Section Seven Limited (9216)

Plot #21-24 (Part), Sector-3, Road-4, South Haliashahar, CEPZ, Chittagong
(+ 22.287786N, 91.775024E)

19.MAY.2014

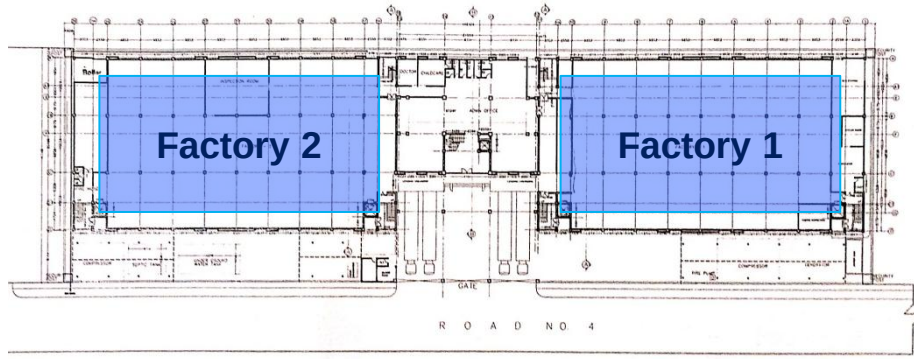
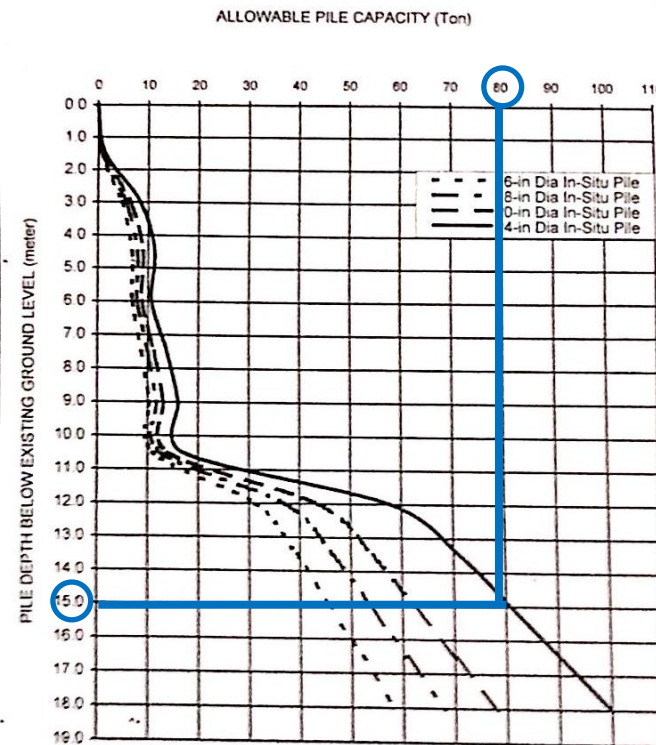
- Capacity check for piled foundation of Factory 1 and Factory 2.

From the drawings, it was appeared to be one pile of each column, where the size equals to 600 mm in diameter and 15 m long, supporting the interior column in area between grid line 1A-10A/A1-C1 of Factory 1 and the area between grid line 16A-25A/A1-C1 of Factory 2. The tributary area is 10.03 m x 5.85 m of 4 storeys with an exclusion of ground floor which is informed to be slab on ground).

From the calculation, the factor of safety (FoS) appears to be **1.38** (Allowable pile capacity 784.8 kN; received from SI report x 2.50 divided by unfactored column load 1426 kN).

Item No.	Observation	Recommended Action Plan	Recommended Timeline
1	Capacity check for piled foundation of Factory 1 and Factory 2.	Factory Engineer to review design, loads and substructure to confirm capacity and suitability for loads applied. Investigate foundation in areas above by excavation and verify pile length by parallel seismic pile testing. Geotechnical investigation in situ and in laboratory. A Detail Engineering Assessment to be commenced. Until this concern is resolved, the loads in the factory, at all floors, must not be increased past the present levels.	Immediate – Now
2	Capacity check for piled foundation of Factory 1 and Factory 2.	Produce and actively manage a loading plan for all floor plates within this area giving consideration to floor capacity and column capacity. Detail Engineering Assessment to be completed.	6-weeks
3	Capacity check for piled foundation of Factory 1 and Factory 2.	Continue to implement load plan	6-months

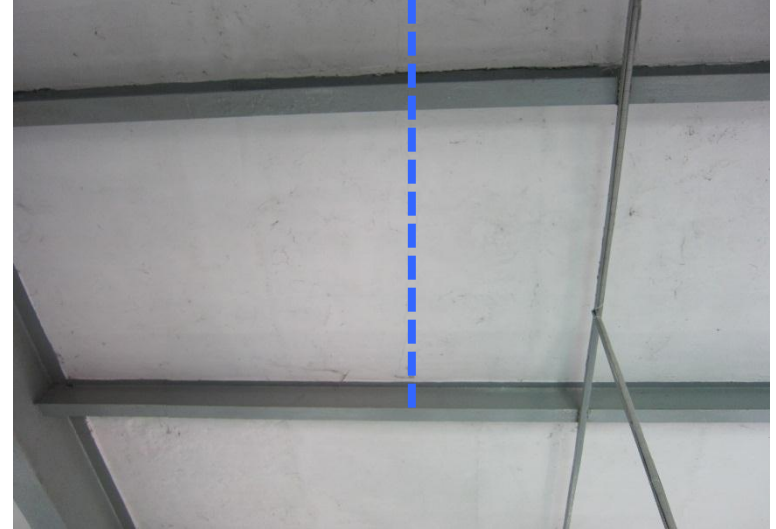
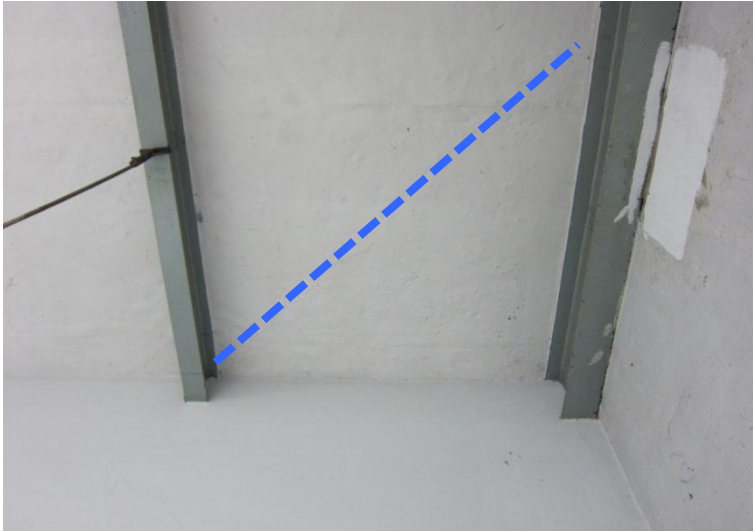
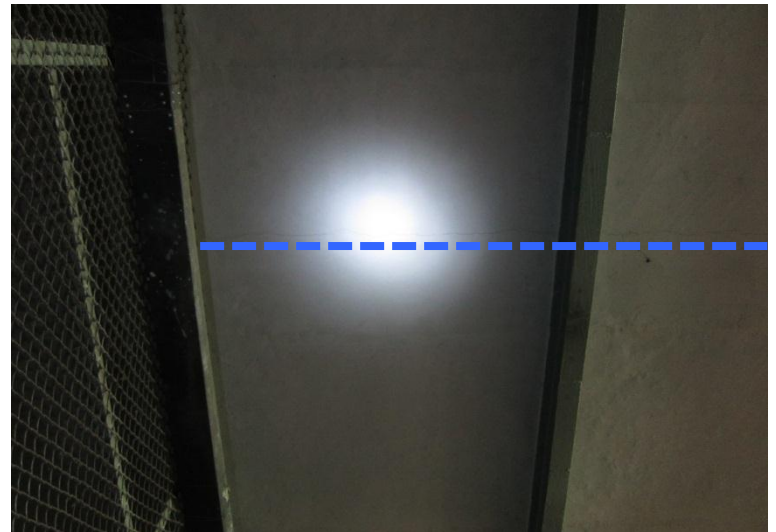
- Cracks appeared on floor slab
- Capacity and stability check for cantilevered grating supporting AC compressor
- No fireproofing for steel structure elements (if required)

These cracks are found underside slab's soffit. Some of them appeared to be the same cracks pattern on the top and underside of slab's soffit. It is not clear whether these cracks are structural cracks. We require that these items be investigated in a Detail Engineering Assessment.

There are concerns on the cantilevered grating supporting AC compressor. Capacity and stability check of these items and related elements should be carried out.

No fireproofing material is applied to the structural steel elements. It is unclear whether it is required by BNBC.

4	Cracks appeared on floor slab.	The Factory Engineer to investigate the cause of cracks by appropriate methods. The distress found is to be suitably rectified and then repaired.	6-weeks
5	Cracks appeared on floor slab.	Create loading plans for each floor level. Maintain standards of quality control to ensure that loading plan is correctly followed so that problems do not arise in the future. Maintain and enforce the loading plans.	6-months
6	Capacity and stability check for cantilevered grating supporting AC compressor.	Factory Engineer to review design, loads and related elements in area identified above to confirm capacity and stability for these items.	6-weeks

Item No.	Observation	Recommended Action Plan	Recommended Timeline
7	No fireproofing for steel structure elements (if required).	Fireproofing material for structural steel element is recommended as suggested in BNBC Codes.	6-weeks
8	No fireproofing for steel structure elements (if required).	Maintain standard of quality control.	6-months
9	Overall stability system.	Request that the Detail Engineering Assessment of the overall building to be carried out and in particular, stability and foundation aspects should be investigated in detail.	6-weeks
10	Distress due to water ingress.	Factory Engineer to inspect water damaged structures and repair with a suitable method.	6-weeks
11	Distress due to water ingress.	For both durability and serviceability, rustproofing is recommended. Waterproofing on the roof slab is recommended. Moreover the slab drainage system should be investigated. Maintain standard of quality control.	6-months
